UNITED STATES
NUCLEAR REGULATORY COMMISSION
OFFICE OF INSPECTION AND ENFORCEMENT
WASHINGTON, D.C. 20555

October 16, 1979

IE Bulletin No. 79-13
Revision 2

CRACKING IN FEEDWATER SYSTEM PIPING

FIGURE 1
FEEDWATER PIPE ELBOW TO STEAM GENERATOR
NOZZLE INSTALLATION (DC COOK)

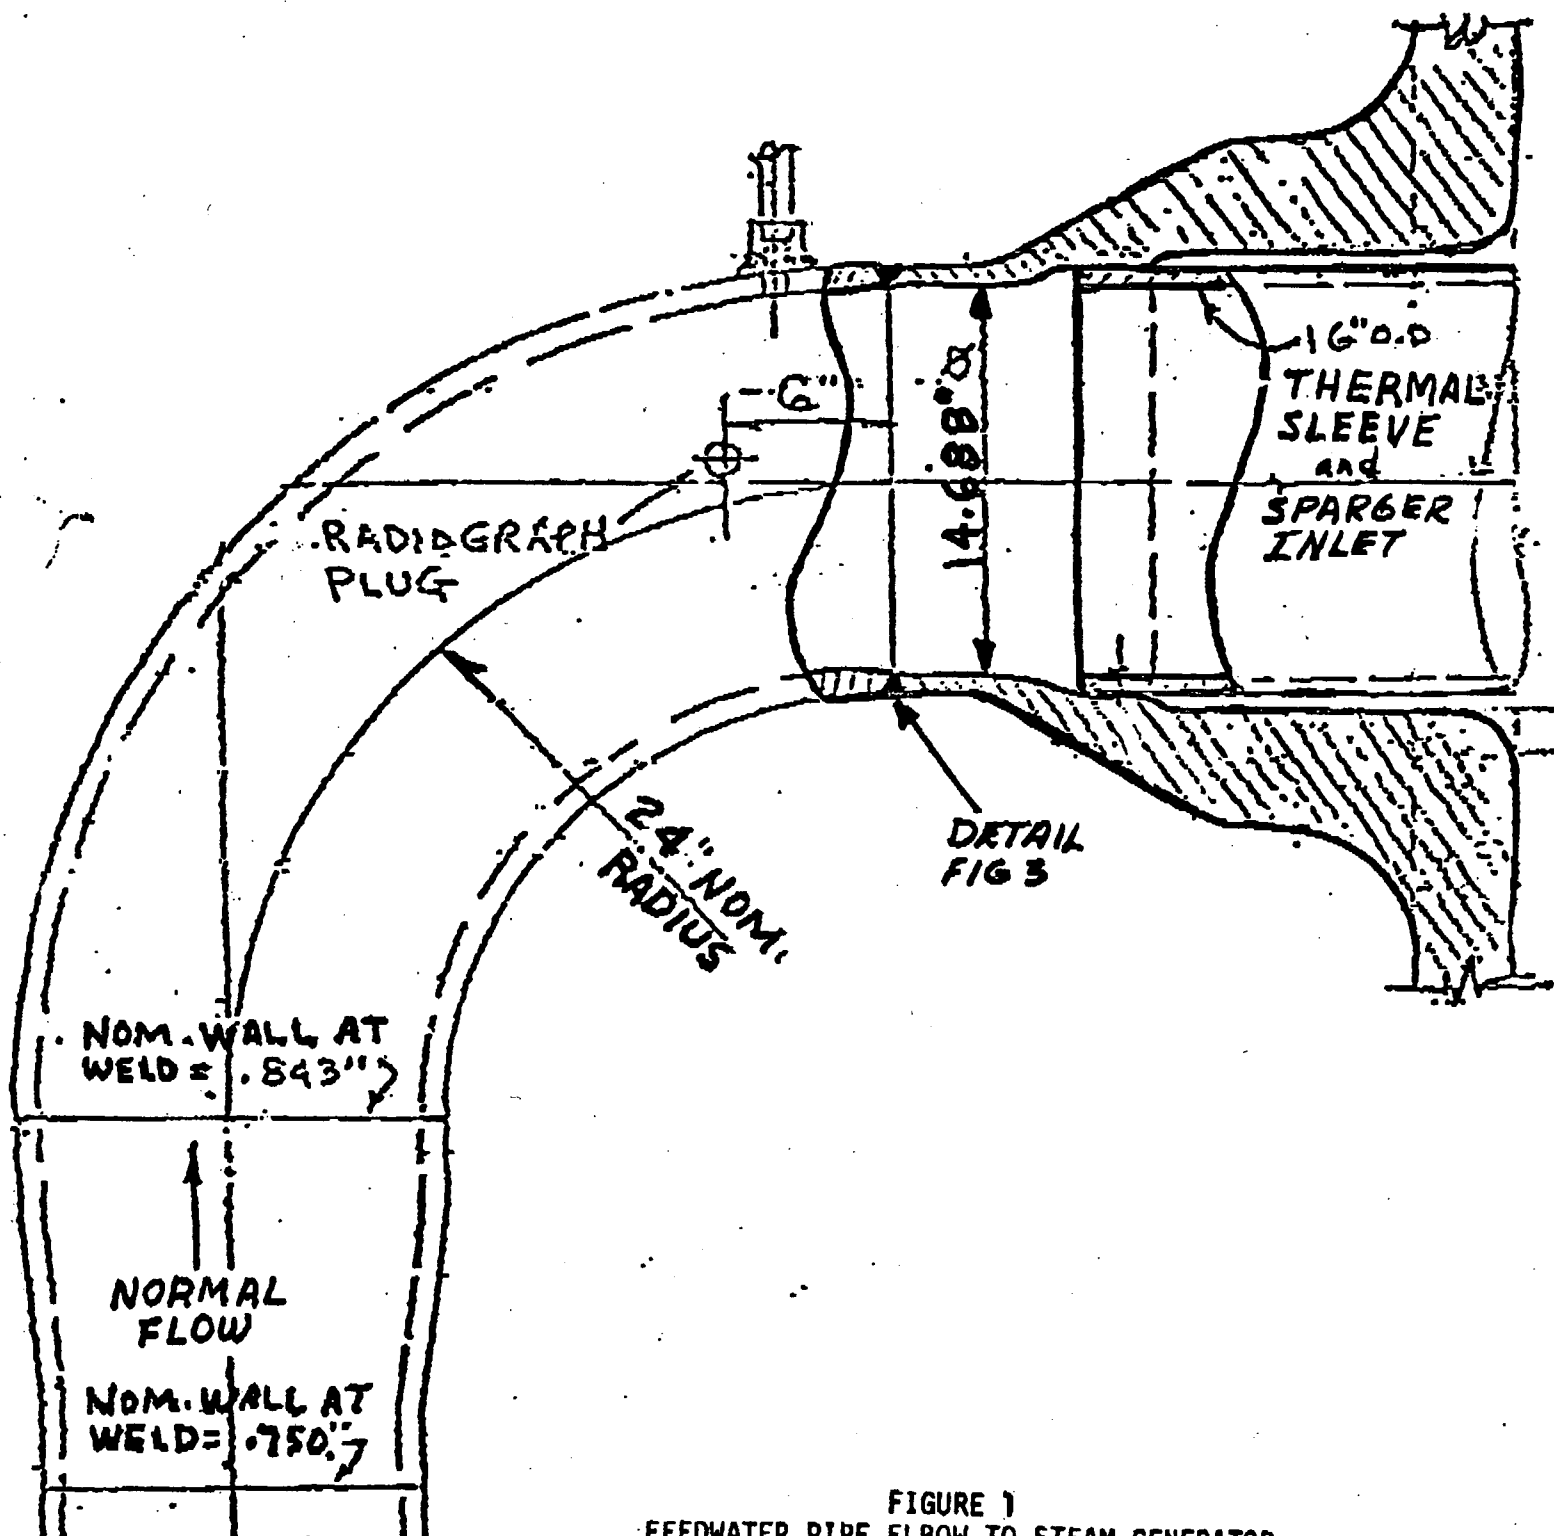
On May 20, 1979, Indiana and Michigan Power Company notified the NRC of cracking in two feedwater lines at their D. C. Cook Unit 2 facility. The cracking was discovered following a shutdown on May 19 to investigate leakage inside containment. Leaking circumferential cracks were identified in the 16-inch feedwater elbows adjacent to two steam generator nozzle elbow welds. Subsequent radiographic examination revealed crack indications in all eight steam generator feedwater lines at this location on both Units 1 and 2.

The feedwater nozzle-to-pipe configurations for D. C. Cook and for San Onofre are shown on the attached figures 1 and 2. A typical feedwater nozzle-to-pipe weld joint detail showing the principal crack locations for D. C. Cook and San Onofre are shown on the attached figure 3.

FIGURE 2
FEEDWATER PIPE REDUCER TO STEAM GENERATOR
NOZZLE INSTALLATION (SAN ONOFRE)

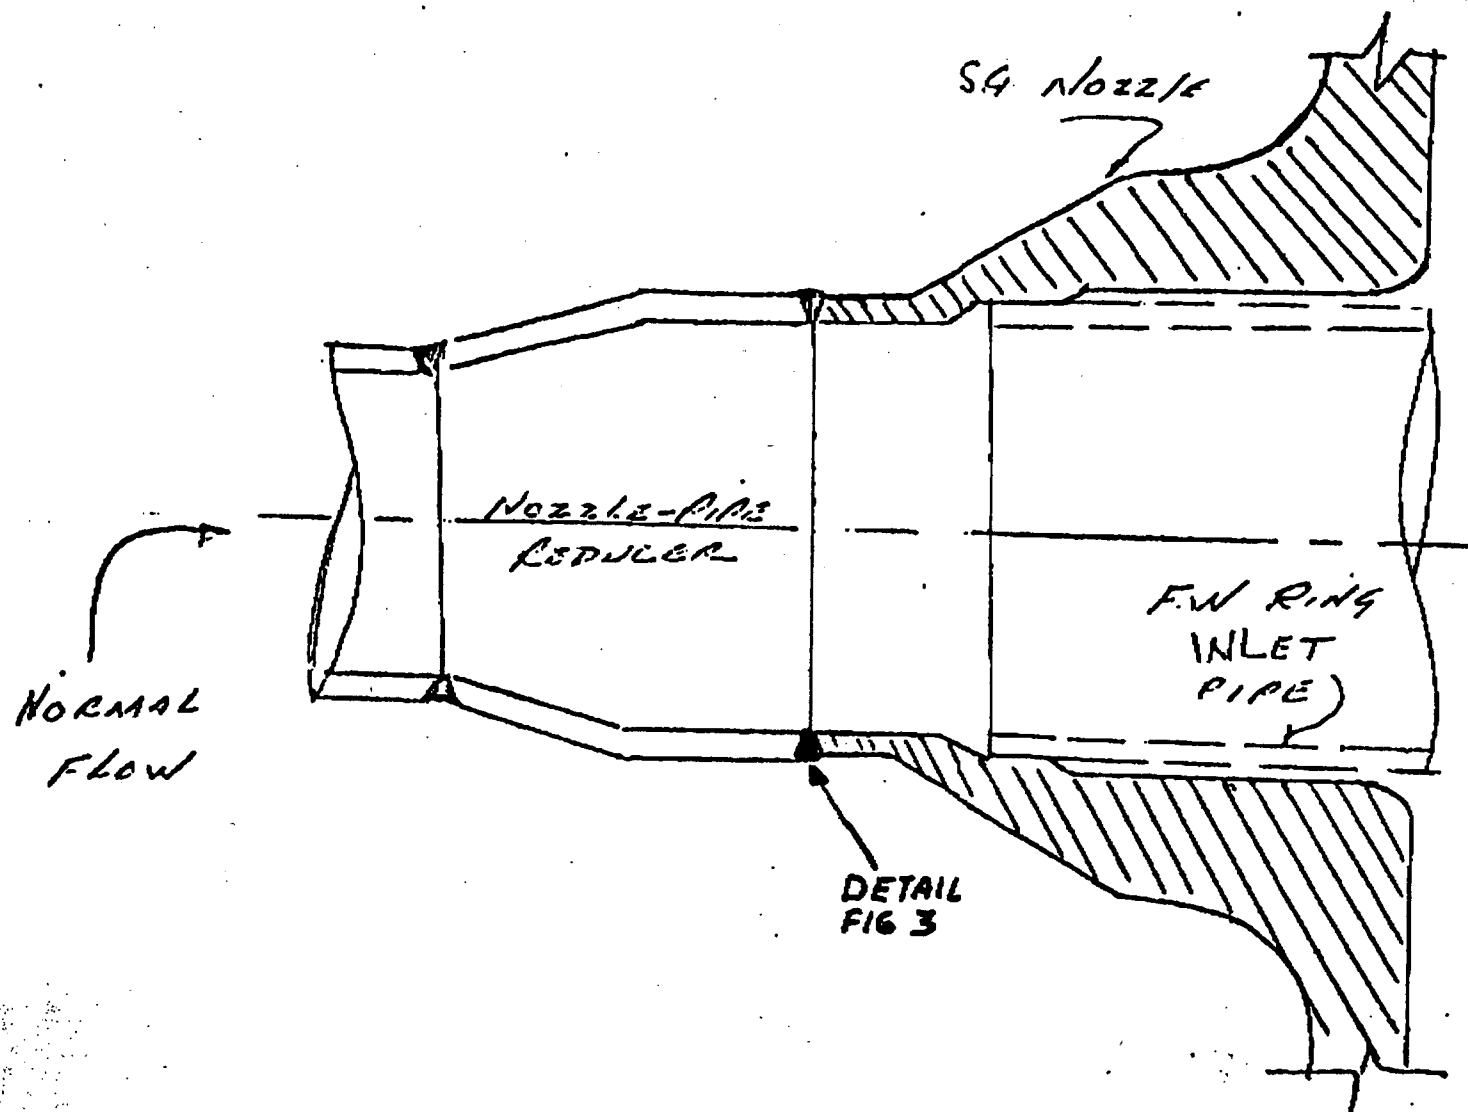
As a result of these actions, several other licensees with Westinghouse steam generators reported crack indications. Southern California Edison reported on June 5, 1979, that radiographic examination revealed indications of cracking in feedwater nozzle-to-pipe welds on two of three steam generators of San Onofre Unit 1. On June 15, 1979, Carolina Power and Light reported that radiography showed crack indications in similar locations at their H. B. Robinson Unit 2. Duquesne Power and Light confirmed on June 18, 1979, that radiography has shown cracking in their Beaver Valley Unit 1 feedwater piping-to-vessel nozzle weld. Public Service Electric and Gas Company reported on June 20, 1979 that Salem Unit 1 also has crack indications. Wisconsin Public Service company decided on June 20, 1979 to cut out a feedwater nozzle-to-pipe weld which contained questionable indication, for metallurgical examination. As of June 22, 1979 and since May 25, 1979 seven other PWR facilities have inspected the feedwater nozzle-to-pipe welds without finding cracking indications.
